Work Order ID 152400

Item Name: AS350/AS355 Quick Release Heli-Utility-Basket™ Long, Heavy Duty Lid

DART SERVICE INSTRUCTION

TO AMEND INSTALLATION INSTRUCTIONS D350-607-3 Rev.D,
INSTALLATION INSTRUCTIONS D350-607-4 Rev. C AND
INSTRUCTIONS FOR CONTINUED AIRWORTHINESS ICA-D350-607 REV. 6

FIGURE 1: INSTALLATION OF D4775-041 FWD STRUT

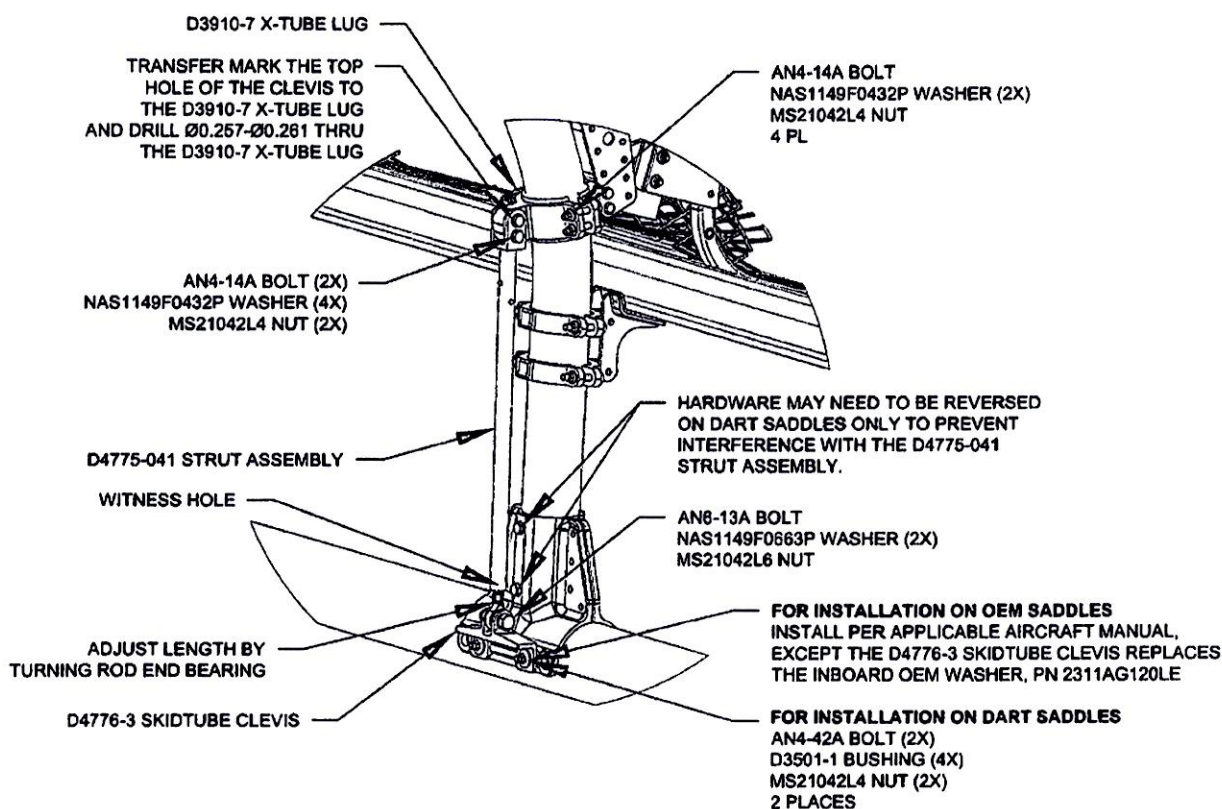
- 3.1 Substitute the Forward Lower D3910-5 X-Tube Lug with the D3910-7 X-Tube Lug as shown in Figure 1.
- 3.2 Install the forward D4775-041 Strut Assembly. Transfer mark from the upper hole on the clevis of the D4775-041 Strut Assembly to the D3910-7 X-tube Lug and drill thru the lug $\varnothing 0.257$ - $\varnothing 0.261$ as shown in Figure 1. Touch up chemical conversion coating per MIL-DTL-5541. Check the witness holes located at the bottom end of the D4775-041 Strut Assemblies to ensure that the thread from the rod end extends past the witness hole.
Torque MS21042L4/-4 nuts to 50-70 in-lbs (5.7-7.9 N-m). Torque MS21042L6/-6 nuts to 160-190 in-lbs (18.1-21.5 N-m).
- 3.3 Complete the installation in accordance with Installation Instructions D350-607-3 Rev. D or D350-607-4 Rev. C.
